P 521640-A

ON-SITE SEWAGE DISPOSAL SYSTEM
HOWARD COUNTY HEALTH DEPARTMENT
BUREAU OF ENVIRONMENTAL HEALTH

ADDRESS: 4705 Manor Lane PROPERTY OWNER: Dillion

521640-A

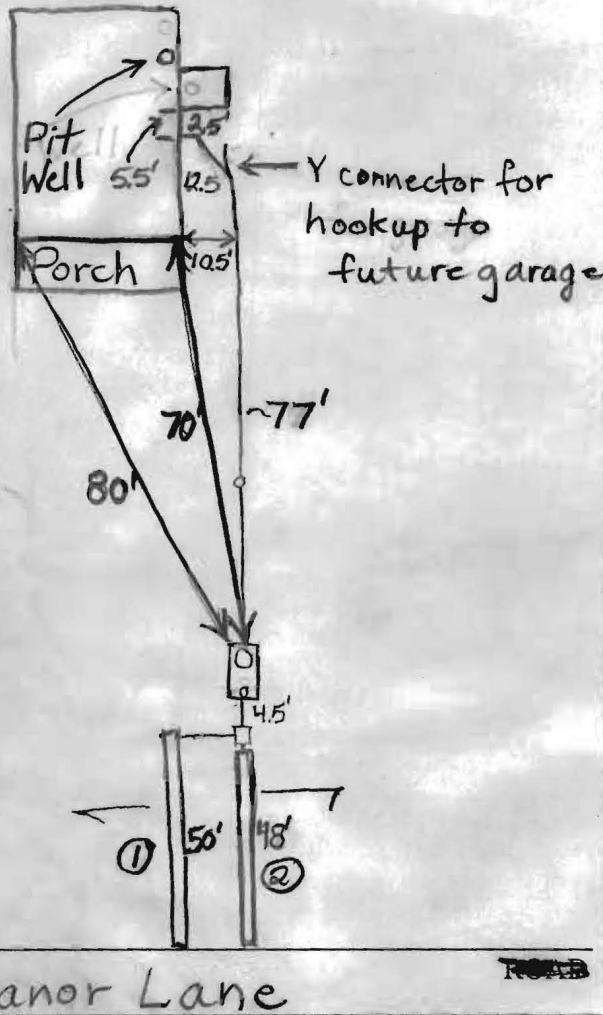
PRE-CONSTRUCTION 12/29/04 Install 2 trenches downhill of the perc test hole and near the driveway. Pump out and fill in the existing cesspool. Need 1500 gallon compartmented tank. Total trench length should be 100'-115'. BB

1/19/05 Robert installed trenches on top of small knoll instead of near driveway. Trench 1 is now somewhat uphill of neighbor's house. Don't know where neighbor's well is. However, the soil looked very good and still 200+ feet from neighbor's property line. Cesspool pumped out and filled in per Robert.
